New Albany Board of Zoning Appeals Agenda

VAR-124-2021 Variance

VAR-126-2021 Variance

Development Review

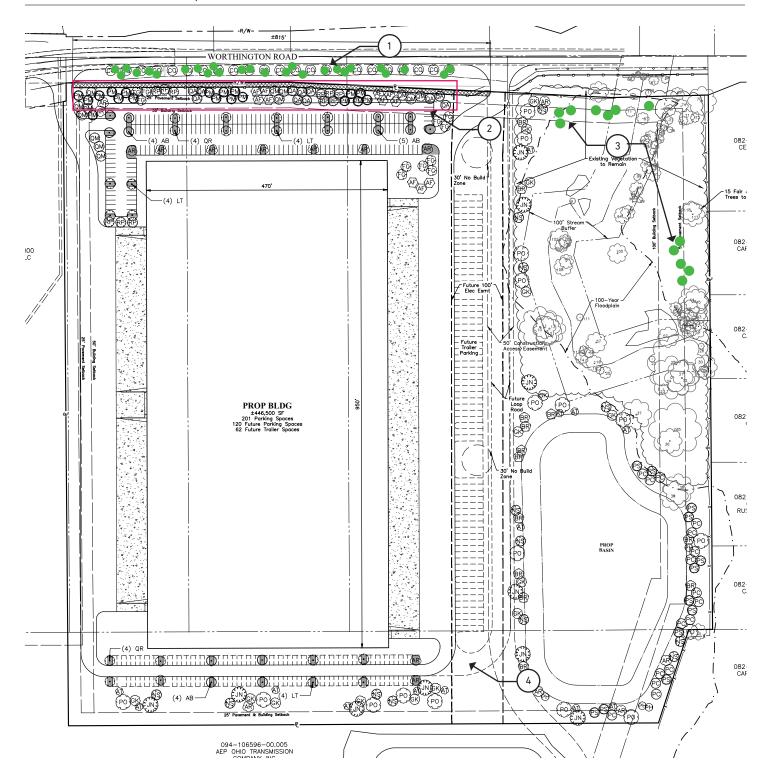
- 1. Street trees along Worthington Rd. should be planted in random massings of deciduous shade trees to reflect the rural character of existing road. Include a minimum of 3 different species. See diagram.

- 2. The proposed trees on the southern edge of the leisure trail should include some evergreens to assist with screening from the residents on the north side of Worthington Road. Please replace 25% of the proposed trees with evergreen tree species. See diagram.

- 3. Though the existing trees play an important role for screening from adjacent properties, it is not enough to meet the required 75% opacity within 5 years. There are significant holes within the existing tree stands, leaving the interior of the site exposed to the right-of-way patrons. Plant additional deciduous and evergreen trees in specific locations to fill the gaps to ensure screening will reach 75% opacity within 5 years. See diagram.

4. The city is concerned the future road extension from the southern parking lot and truck parking. The turn radii and the pavement width seem too wide. Submit plans for final future road alignment for approval. See diagram.
